Project	<b>IEEE 802.16 Broadband Wireless Access Working Group</b> < <a href="http://ieee802.org/16">http://ieee802.org/16</a> >	
Title	<b>Short Initial-Ranging Transmission for IEEE 802.16e OFDMA</b>	
Date Submitted	<b>2003-09-09</b>	
Source(s)	Hyoungsoo Lim Dong Seung Kwon ETRI 161 Gajeong-Dong, Yuseong-Gu Daejeon, Korea	Voice: +82-42-860-1608 Fax: +82-42-860-6732 <a href="mailto:lim@etri.re.kr">mailto:lim@etri.re.kr</a>
Re:	Task Group Review of IEEE 802.16e-03/07r3	
Abstract	This contribution is to propose a modification to the length of the initial-ranging transmission for IEEE 802.16e OFDMA.	
Purpose	Task group approval of the modification.	
Notice	This document has been prepared to assist IEEE 802.16. It is offered as a basis for discussion and is not binding on the contributing individual(s) or organization(s). The material in this document is subject to change in form and content after further study. The contributor(s) reserve(s) the right to add, amend or withdraw material contained herein.

# Short Initial-Ranging Transmission for IEEE 802.16e OFDMA

Figure 4–Proposed initial-ranging transmission for OFDMA

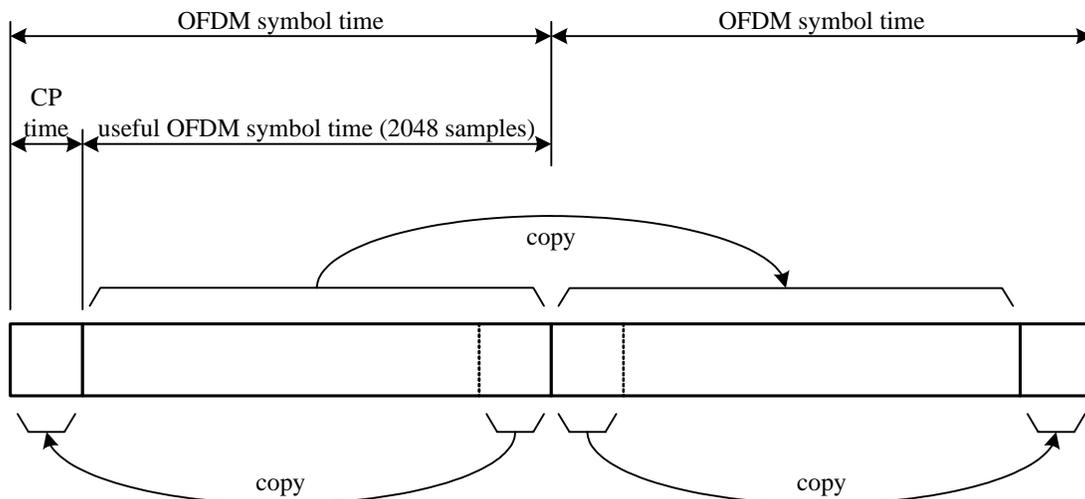
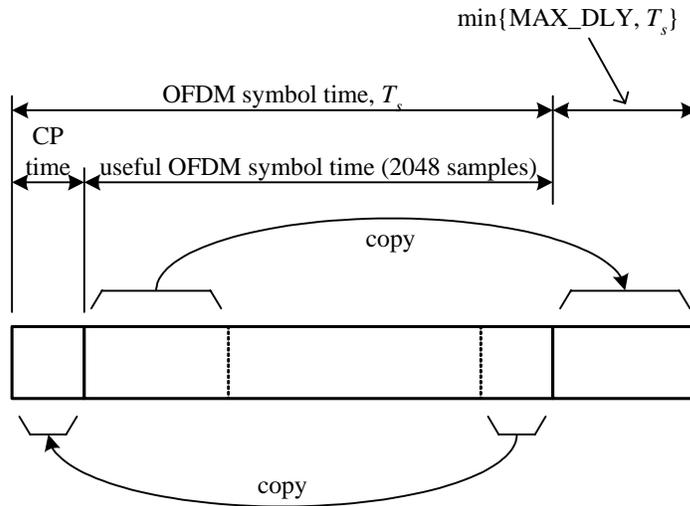
Unlike the preceding portion of the RNG-B in the  $(k-1)$ st OFDM symbol epoch, the portion of RNG-B in the  $(k+1)$ st OFDM symbol epoch can be shortened to reduce the interference to other uplink transmissions. Since the only purpose of the second repetition in an initial-ranging transmission is to guarantee a complete continuous-phase signal during the intended OFDM symbol epoch at the BS, the length of the initial-ranging transmission has only to be  $T_s + \text{MAX\_DLY}$ , where  $T_s$  denotes the OFDM symbol time and MAX\_DLY denotes the maximum round trip delay between the BS and an SS within the cell. The length of the initial-ranging transmission is limited to  $2T_s$ . Figure 4 shows the proposed initial-ranging transmission for improved initial-ranging performance.

Replace Figure 128bc with Figure 4, and delete the second and the third sentences in 8.5.7.1 so that 8.5.7.1 would read as follows:

Replace Figure 128bc with the revised Figure 4, with “MAX\_DLY” replaced with “TTG” and delete the second and the third sentences in 8.5.7.1 so that it would read as follows:

“The initial-ranging transmission shall be used by any SS that wants to synchronize to the system channel for the first time. A time-domain illustration of the initial-ranging transmission is shown in Figure 128bc.”

“The initial-ranging transmission shall be used by any SS that wants to synchronize to the system channel for the first time. A time-domain illustration of the initial-ranging transmission is shown in Figure 128bc.”

Figure 3–Example of successive initial-ranging transmissions adjacent in time

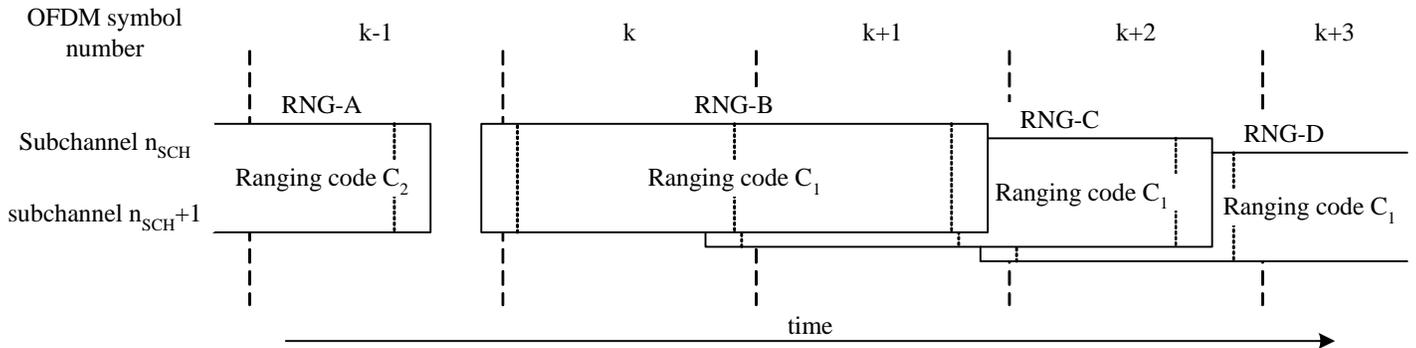
Let us consider the example in Figure 3, where three different SS's initiate initial-ranging at three successive OFDM symbol epochs with an identical ranging code. Ideally, all three initial-ranging transmission should be successfully detected since the SS's have chosen three different epochs. However, with the current design of initial-ranging transmission, the incomplete portions of RNG-B and RNG-C in the  $(k+1)$ st and  $(k+2)$ nd OFDM symbol epochs degrade the detection of RNG-C and RNG-D, respectively.
